ZONING MAP

WINDY HILL PROFESSIONAL OFFICE BUILDING

PETITION NO: Z-5

PLANNING COMMENTS: **Staff Member Responsible:** John P. Pederson, AICP

Z-5

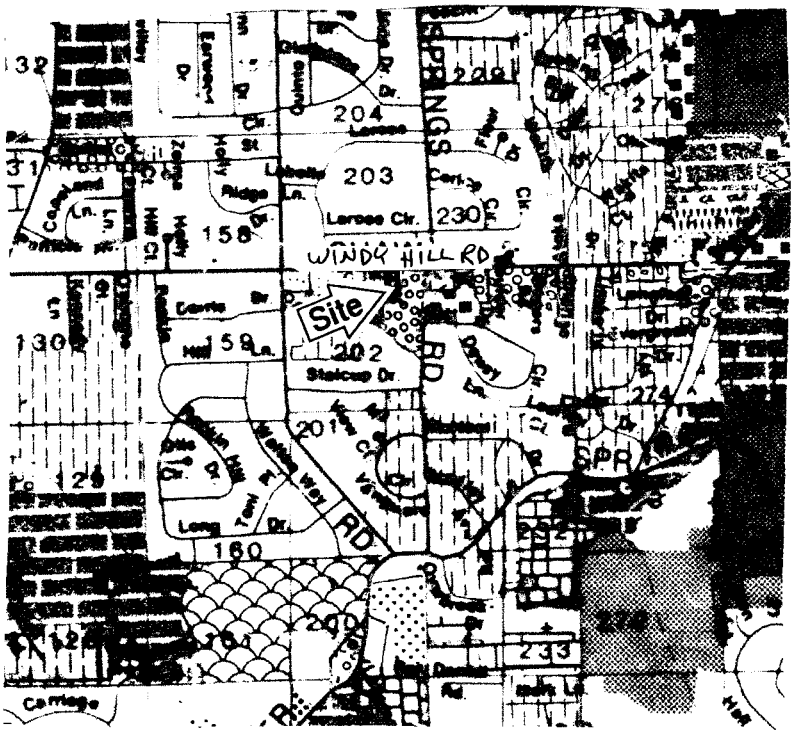
The applicant is showing a contemporaneous variance which is to reduce the side setback adjacent to the east property line from 15-feet to 10-feet.

1. The existing site discharges to the west through the adjacent Piedmont Villas Apartments. There is not adequate stormwater conveyance to accommodate a concentrated discharge from the proposed site through this older apartment complex. The proposed underground detention system must be designed to discharge directly to the existing stormwater system located within the Windy Hill Road R/W.
2. Since a portion of the adjacent St. Jude Episcopal Church property drains through the proposed site, this runoff must be accommodated in the site stormwater design and adequate conveyance provided though the site.

Windy Hill Road is classified as an Arterial and according to the available information, the existing right-of-way does not meet the minimum requirements for this classification.

Recommend applicant consider entering into a development agreement pursuant of O.C.G.A. 36-71-13 for dedication of the following system improvements to mitigate traffic concerns: a) donation of right-of-way on the south side of Windy Hill Road, a minimum of 50' from the roadway centerline.

Based on the above analysis, Staff recommends DELETION to LRO subject to the following conditions:

- Site plan received by the Zoning Division December 6, 2007, with the District Commissioner approving minor modifications;
- Fire Department comments;
- Water and Sewer comments and recommendations;
- Stormwater Management comments and recommendations;
- DOT comments and recommendations; and
- owner/developer to enter into a Development Agreement pursuant to O.C.G.A. §36-71-13 for dedication of system improvements to mitigate traffic concerns.
